VILLAGE OF WEST LAFAYETTE
COSHOCTON COUNTY, OHIO

WWTP OUTFALL & STORM SEWER OUTFALL IMPROVEMENTS

ADDENDUM #1

AUGUST 22, 2023

STATE OF OHIO DEPARTMENT OF TRANSPORTATION TRANSPORTATION ENGINEER Jeffery E. Syar
DATE OF SHEET 7-20-01 7-19-02 7-20-12 1-18-13 1-15-16 7-16-21
DESIGNER M. COZZOLI
PROJECT NAME MANHOLE No. 1
DATE MH-1
SHEET NO. 1 / 2

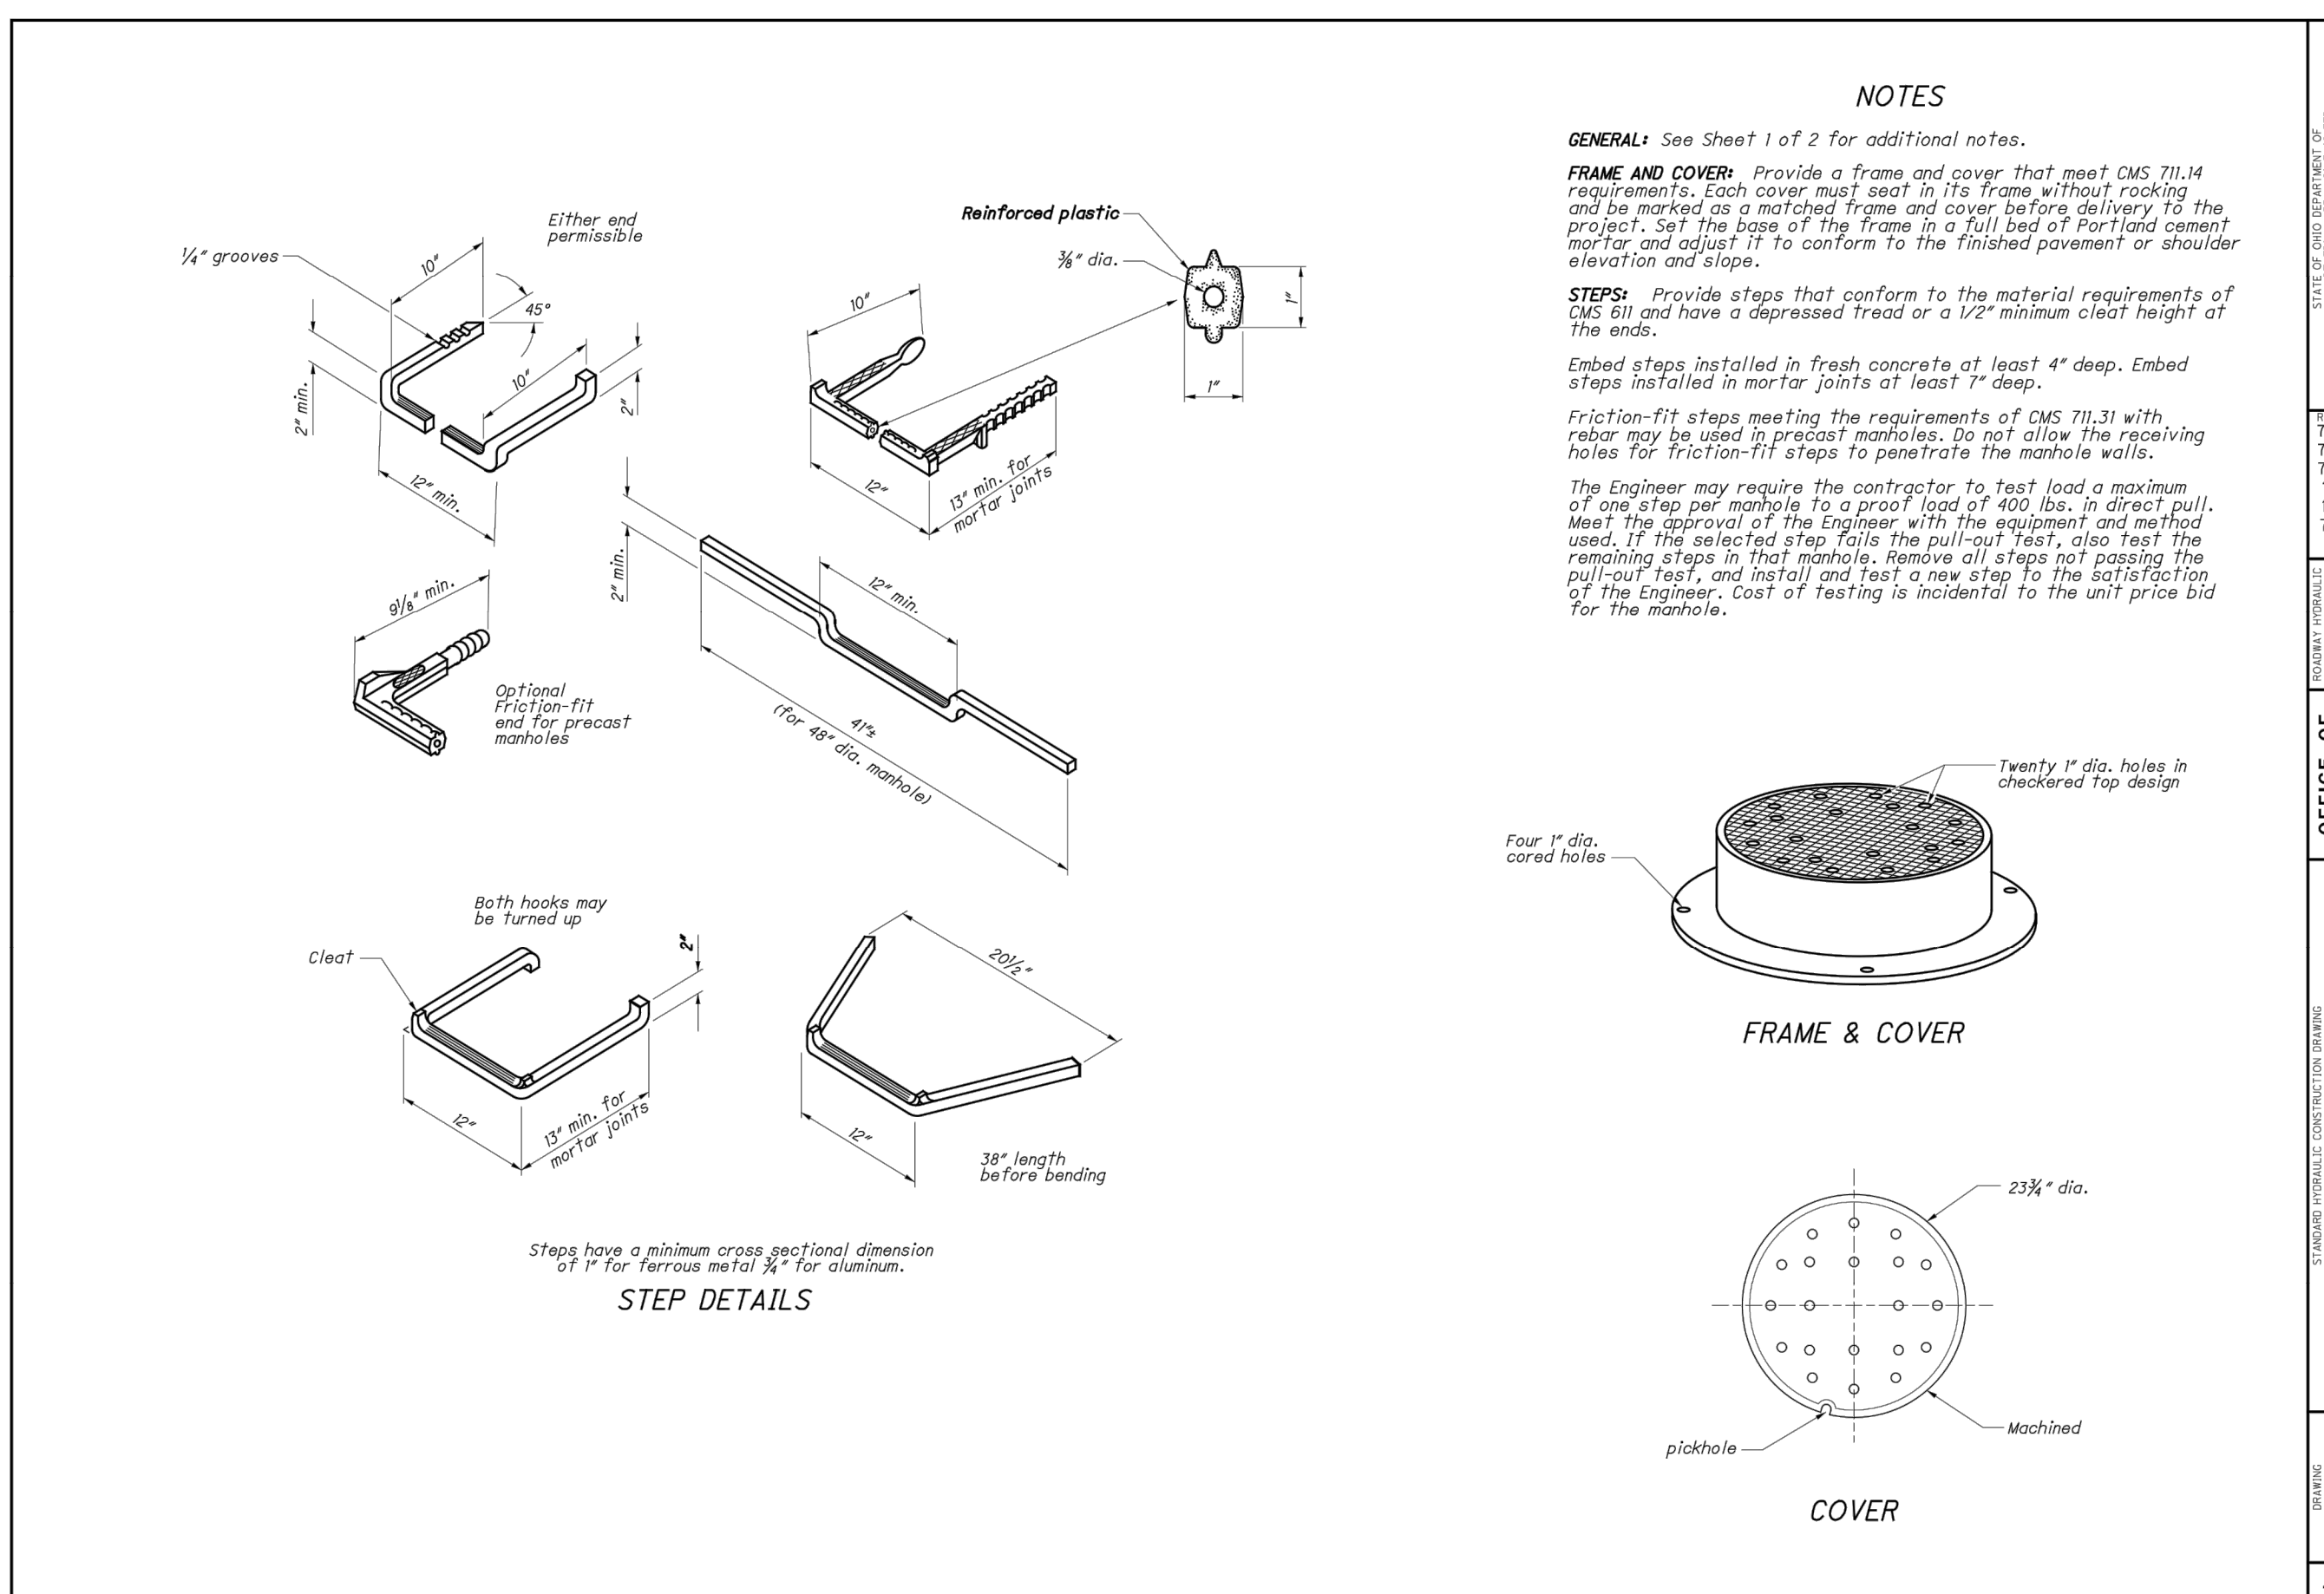
1. Is the detail on page 27 used only on the pile pointed to on sheet 18?

The detail on page 27 is used for all piles in the project. There are a total of 58 piers with 2 Helical piles per pier.
